Plymouth Downtown Development Authority Meeting Agenda March 9, 2026 7:00 p.m. Plymouth City Hall & Online Zoom Webinar

In January of 2026, Fishbeck prepared bid specifications for the 2026 Central Parking Deck Maintenance Project. Attached are the bid specifications including an addendum. On February 5th, DDA staff and Jeannette Grzeskoviak from Fishbeck held a pre-bid meeting with interested contractors to review bid specifications and answer questions. Six contractors attended the meeting.

City of Plymouth
Plymouth, Michigan
Central Parking Structure Restoration 2026

Sheet: SR103 – Level 2 Plan (reissued)

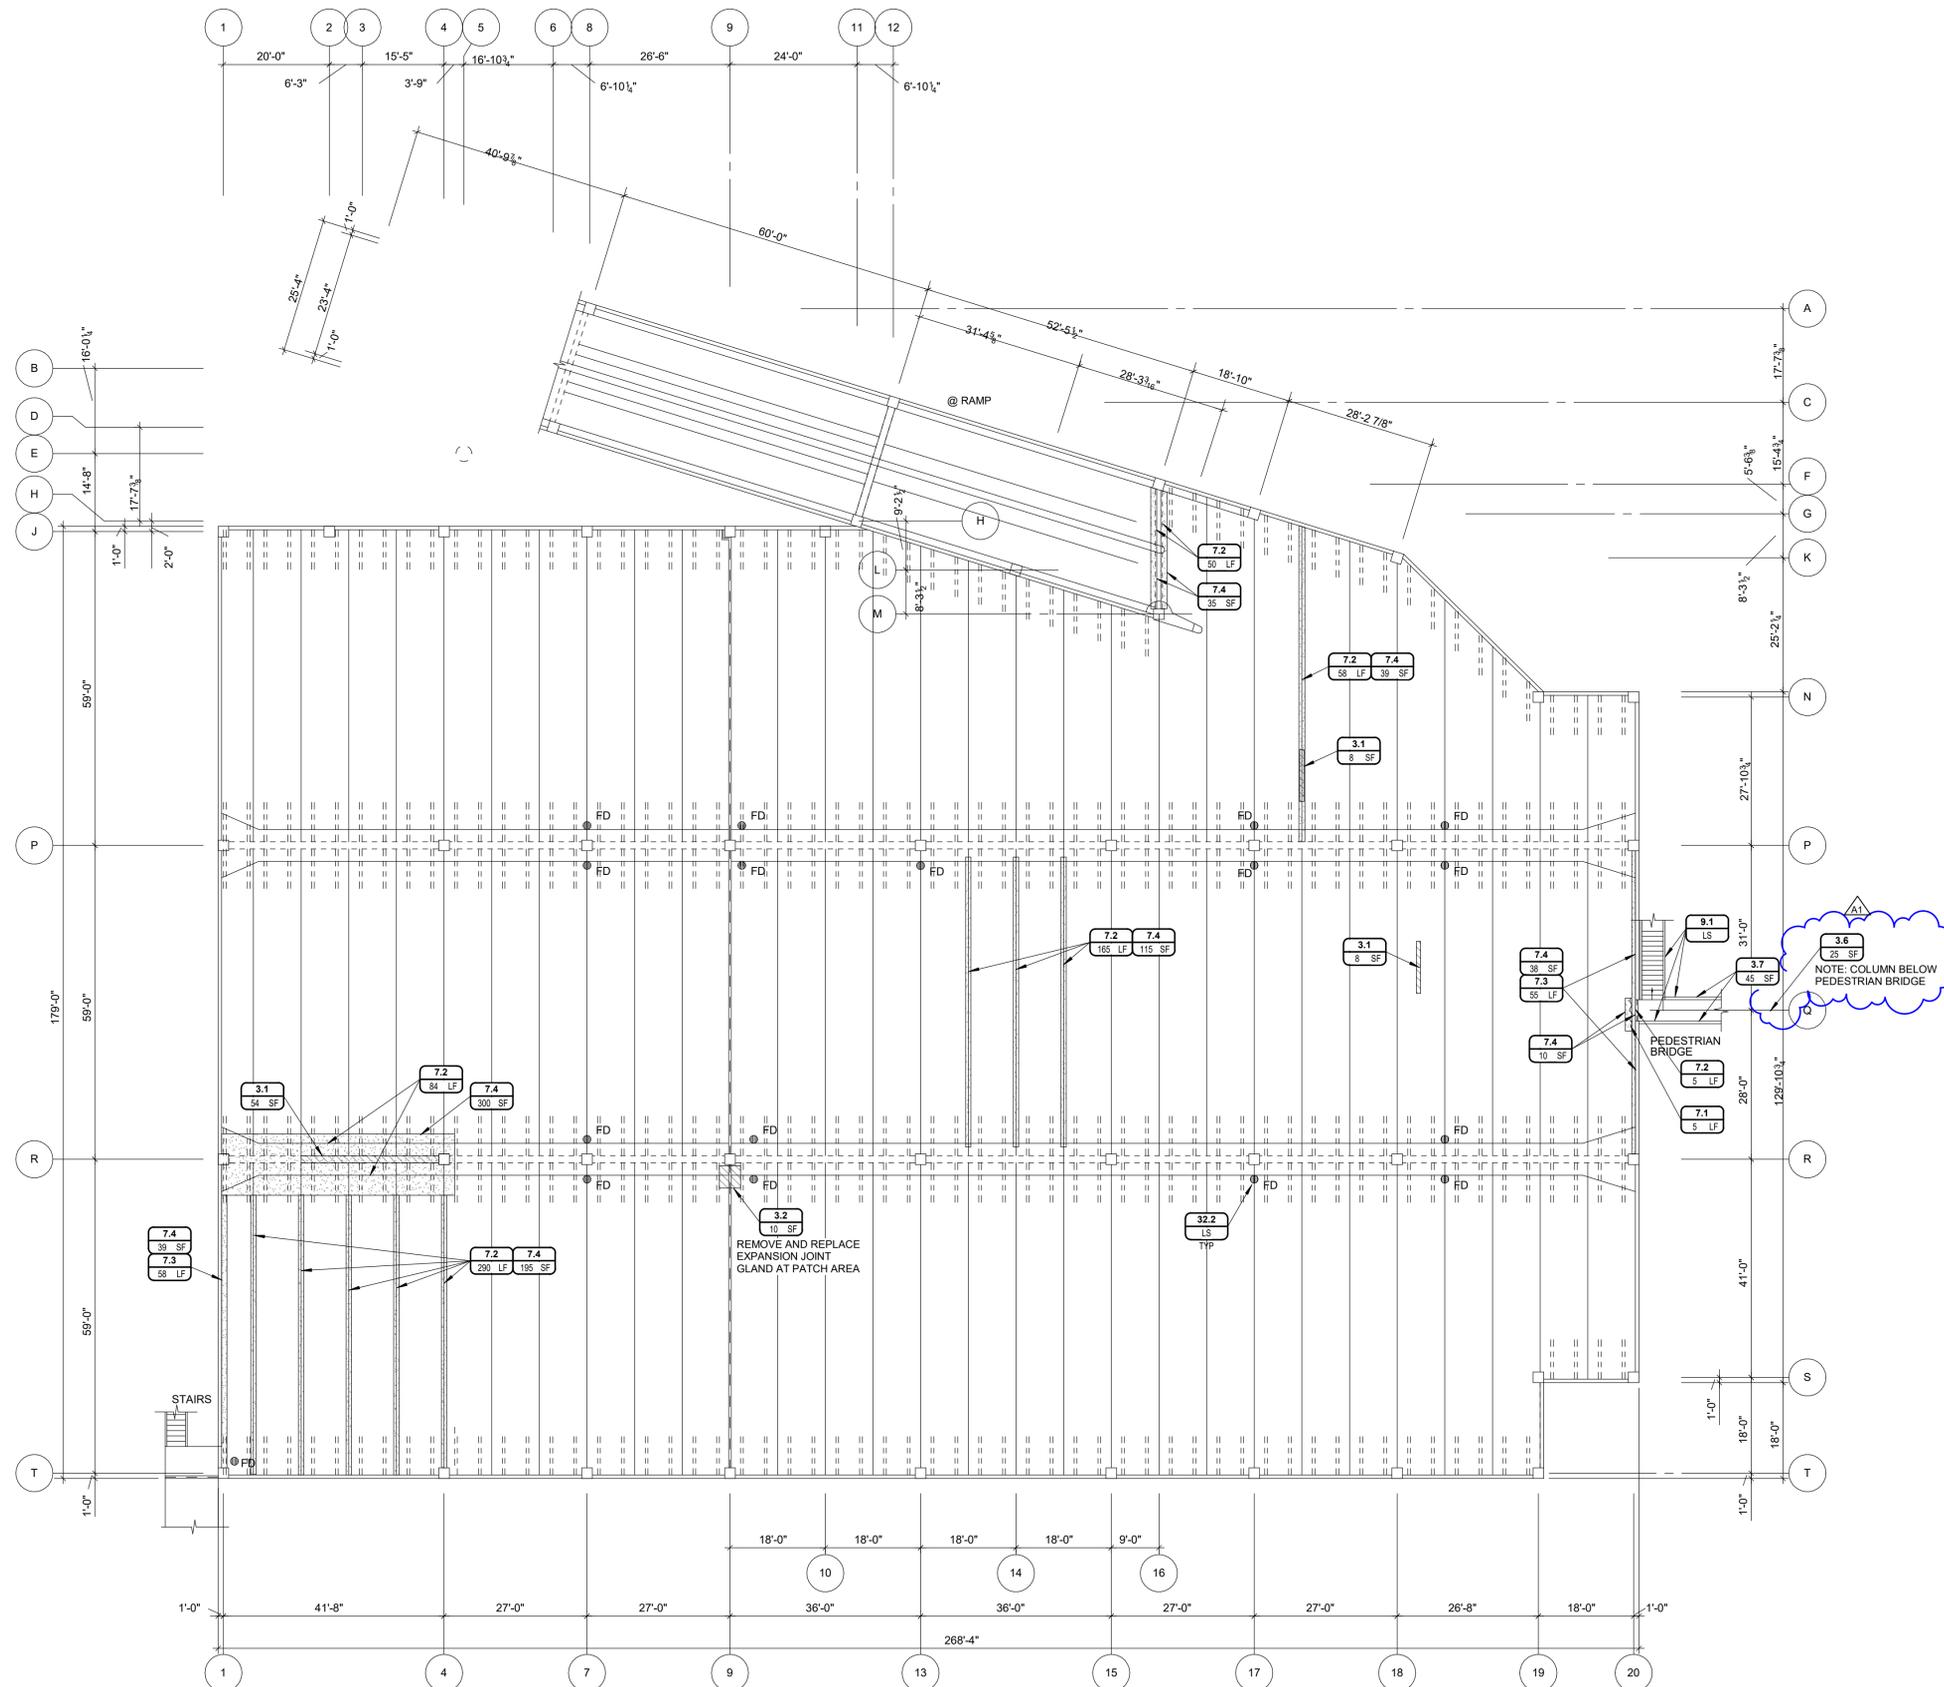
- A. Concrete column and haunch repair at column supporting pedestrian bridge were added.
 B. Location and quantity indicated on Drawing SR103.

9 PRECAST CONNECTION
SCALE: 1 1/2" = 1'-0"

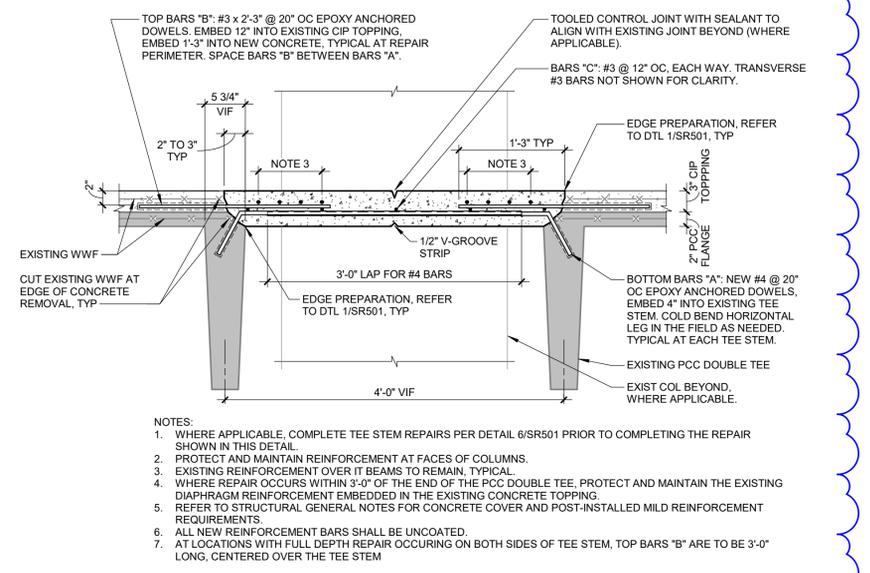
- A. Supplemental steel angles/assemblies for precast connections (Detail 9/SR502) are to be galvanized.
 B. Field welds are to be cleaned, prepared, and coated with a zinc-rich coating, per specification section 05 50 00 – Metal Fabrications, Part 2, Section 2.2, E.

10 PCC FLANGE REPAIR - FULL DEPTH
SCALE: 1" = 1'-0"

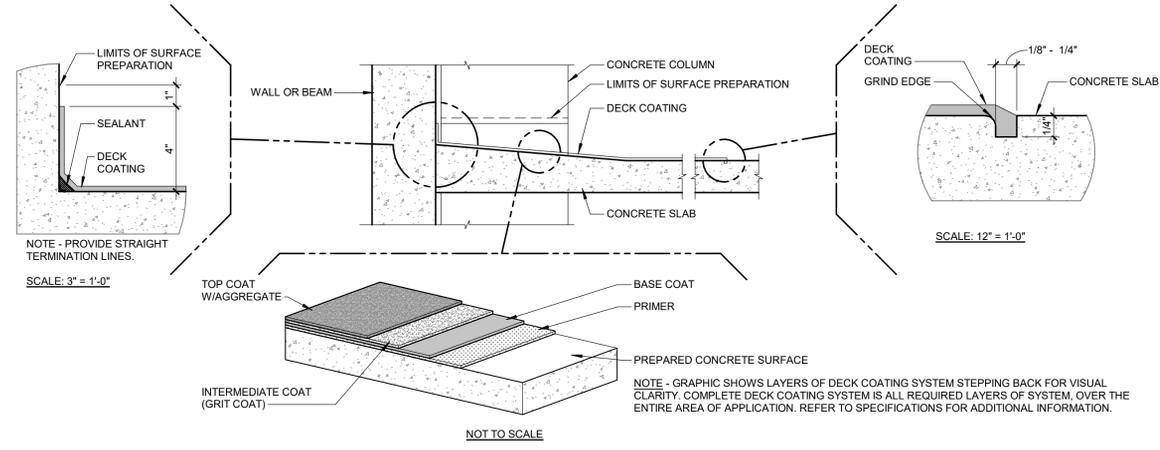
- A. Added Detail 10/SR502 for full depth, precast concrete stem to precast concrete stem repair.

6 DECK COATING DETAIL
SCALE: 1 1/2" = 1'-0"

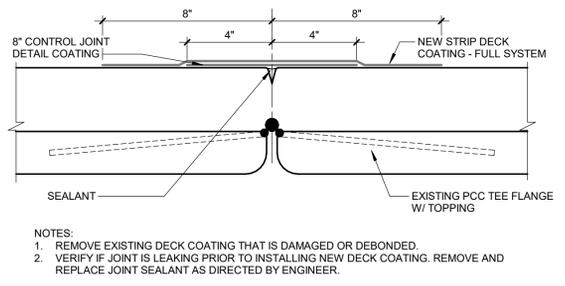
- A. Work Item 7.4 – Remove and Replace Full Traffic Coating System is to include full removal of existing unbonded traffic coating and a full system replacement and to recoat existing, bonded traffic coating per Note 1, Detail 6/SR502.
